DEPARTMENT OF ENVIRONMENTAL PROTECTION
of the University of Heidelberg, Germany
6900 Heidelberg
Im Neuenheimer Feld 360

RADIOECOLOGICAL ASSESSMENT OF THE WYHL NUCLEAR POWER PLANT

May 1978
Revised July 1979

Subject: "Radiological Assessment
of the WYHL Nuclear
Plant," Department of
Environmental Protection of
the University of Heidelberg.
May 1978, Revised July 1979.
NRC Translation 520
(TIDC 520)

COMPARISON OF TRANSPORT FACTORS FOR CESIUM IN PASTURE GROWTH DATA FROM VARIOUS PUBLICATIONS AND SSK COMPUTATIONAL VALUE

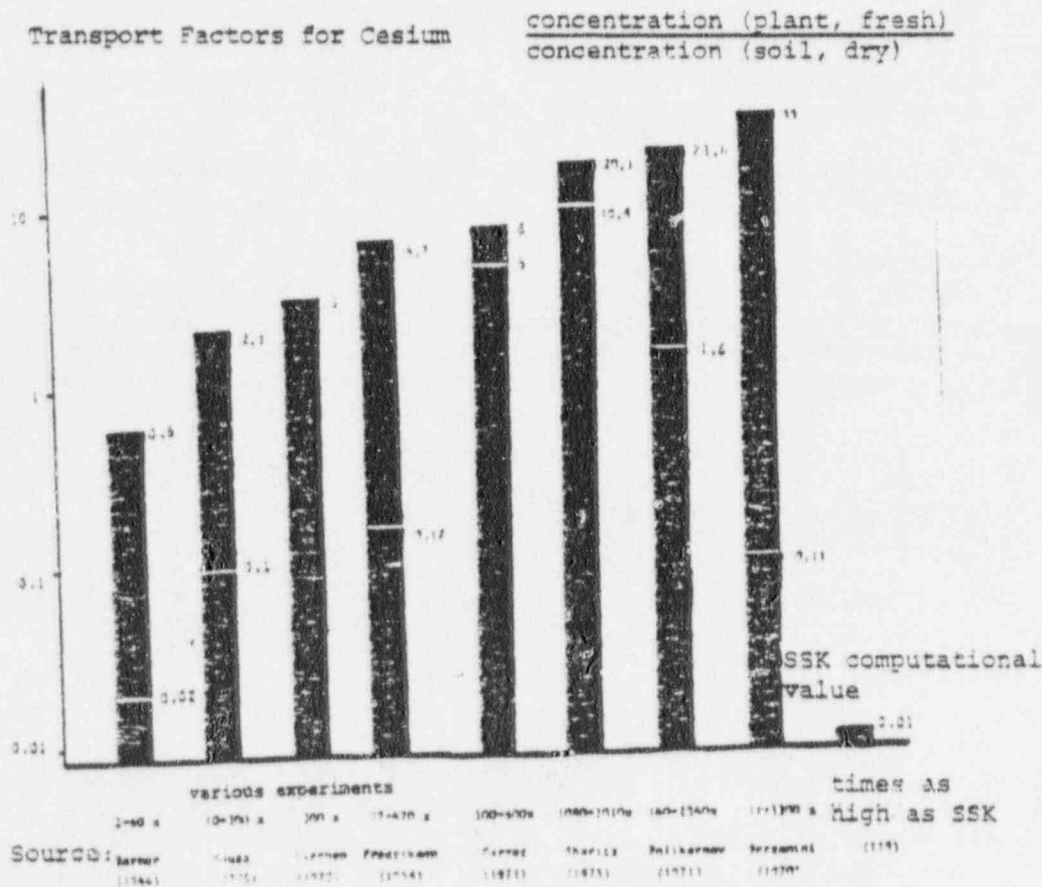
In contrast, the GRS uses cesium-transport factors of between 0.00064 and 0.019. The SSK recommends a value of 0.01.

The following figure contrasts the experimentally determined transport factors for cesium in grass, clover, and leafy vegetables with the values recommended by the SSK.

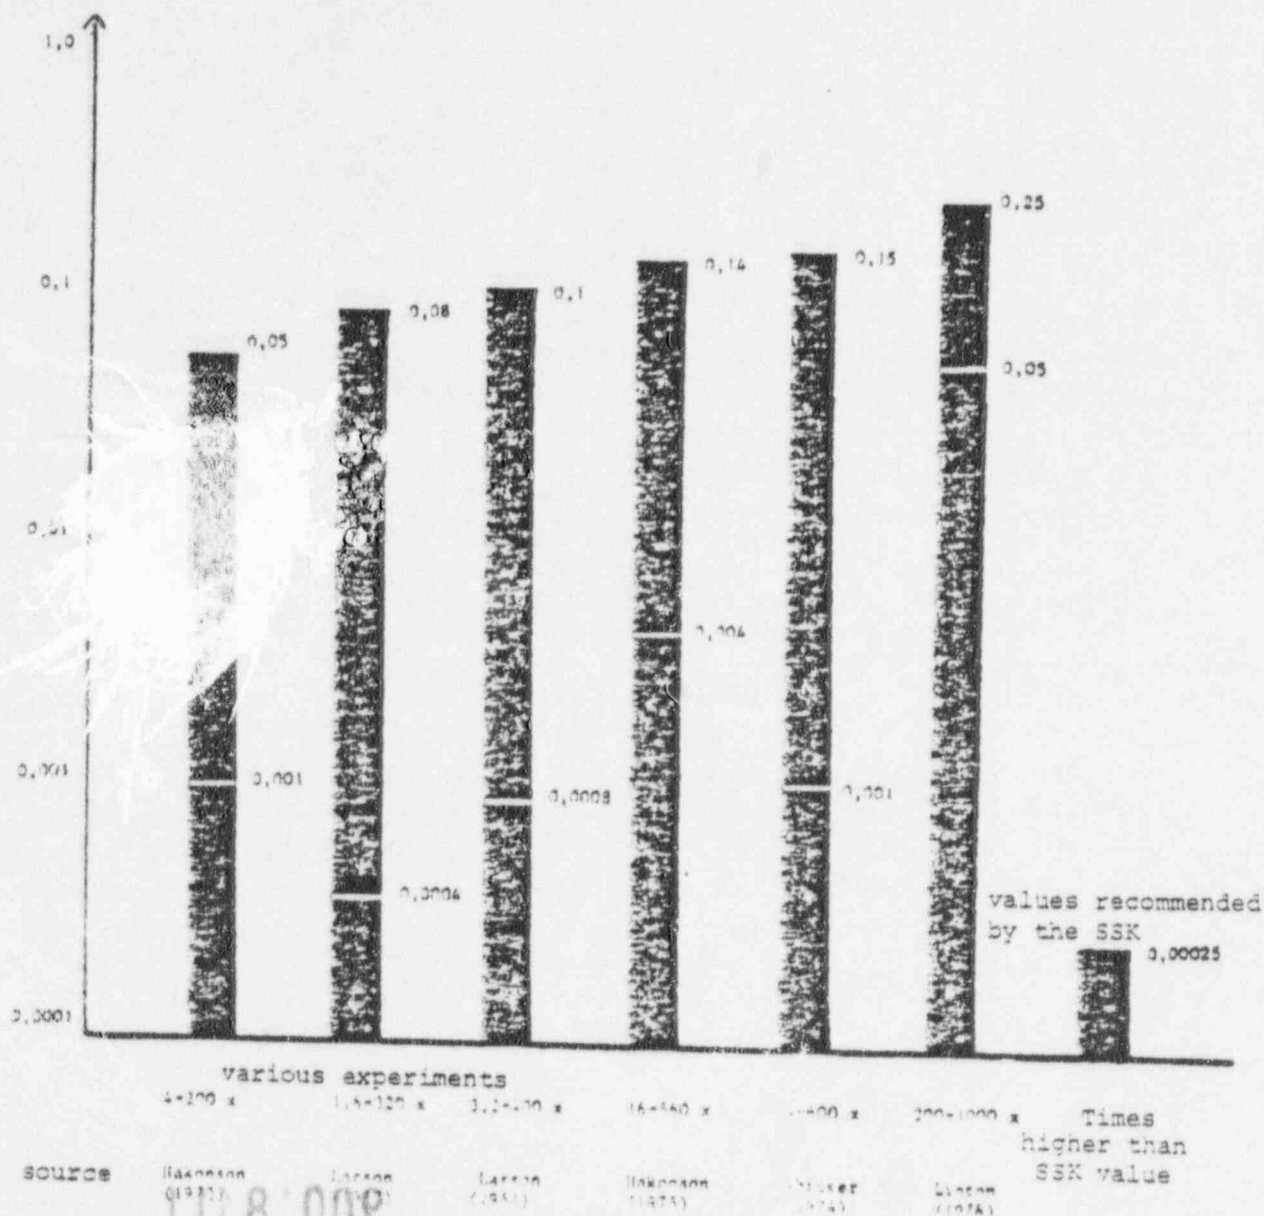
The GRS and SSK use a universal value of 0.00025 as the transport factor of plutonium for all plants. As the following published values show, this value is unrealistically low.

Larsson, K.E. (1951) found values between 0.0084 and 0.101 for plutonium transport factors. The mean value of various measurements was 0.025.

Larsson, K.E. et al. (1957) determined values between 0.00043 and 0.086.

Hakonson, T. E. and Johnson, L.M. (1973 I) studied various types of grass in the open country around a nuclear testing site 20 years after the last nuclear bombs had been detonated. They found transport factors between 0.03 and 4.7.

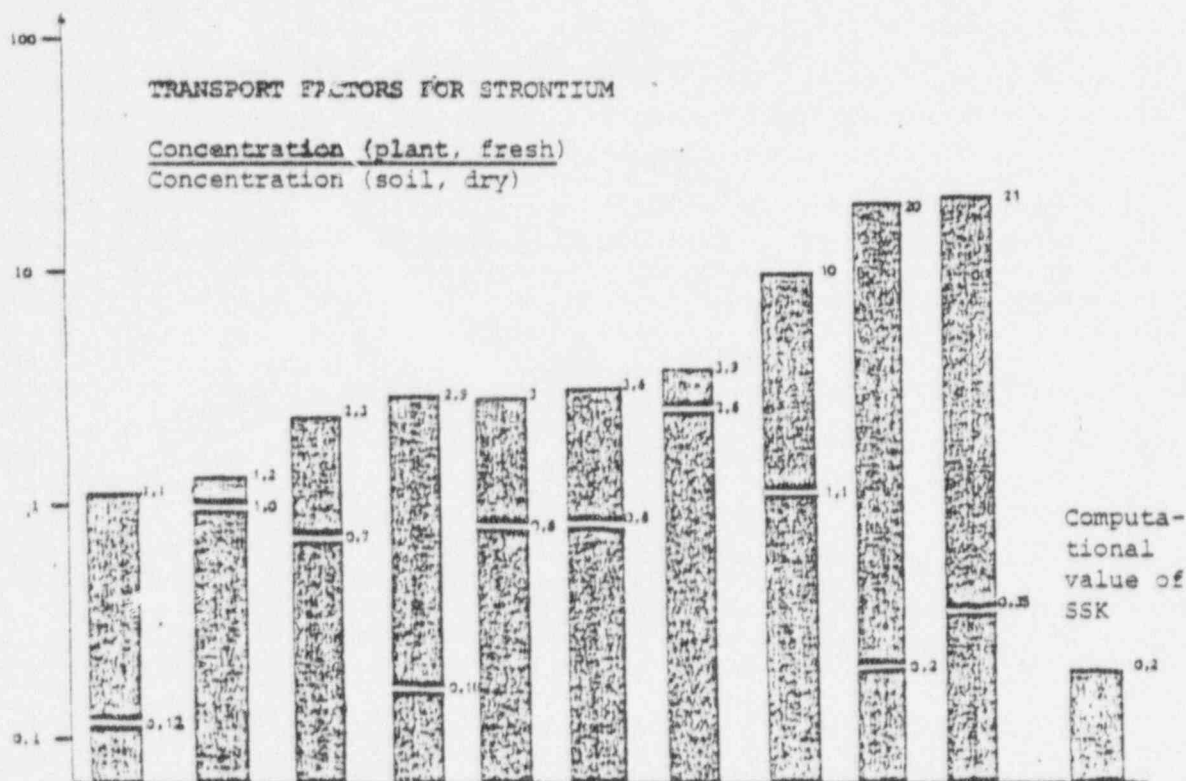
The SSK recommends a transport value of 0.017 (in SSK, 1977 I) and of 0.2 (in SSK, 1977 II) for strontium for all plants.

The figure on this page gives a graphic summary of the results of concentration experiments on strontium.

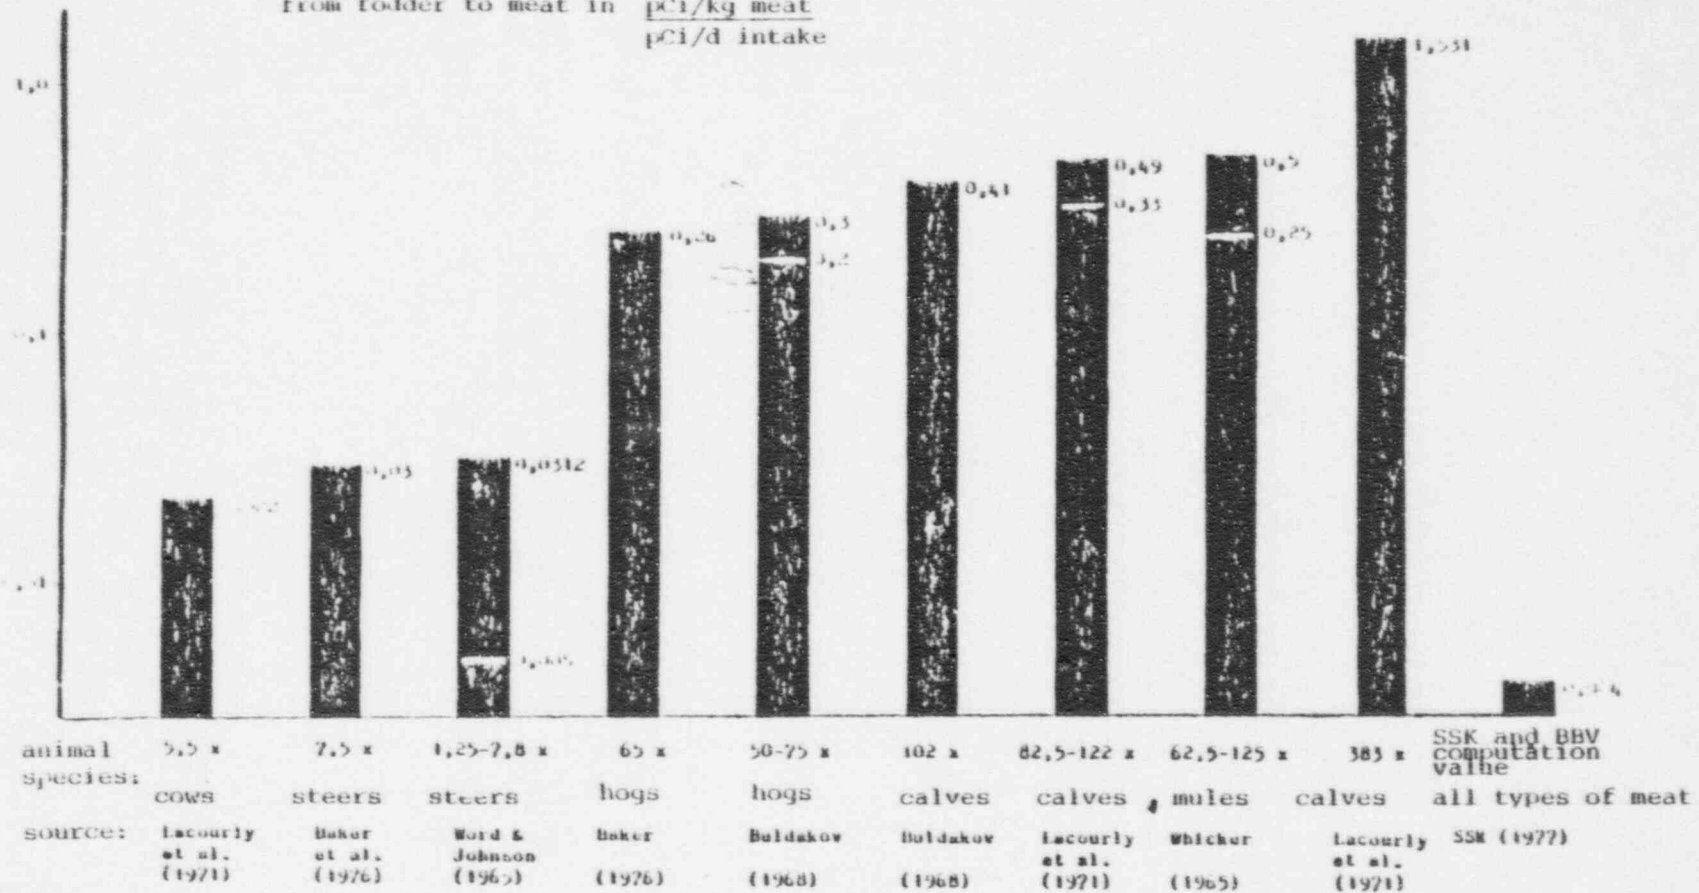
The transfer coefficients that are recommended by the Radiation Protection Commission (SSK, 1977) for calculating radionuclide transport from the fodder to the meat and milk and that are used, for example, in assessments by the Bavarian Biological Testing Institute for the Wyhl plant (BBV, 1976) were compared by the Department of Environmental Protection with published values. The following graph shows the results of this study for the example of the radionuclide cesium and for the transport to meat.

The graph shows that the value recommended by the SSK is smaller than realistic values by a few powers of ten for this extremely important route of exposure as well.
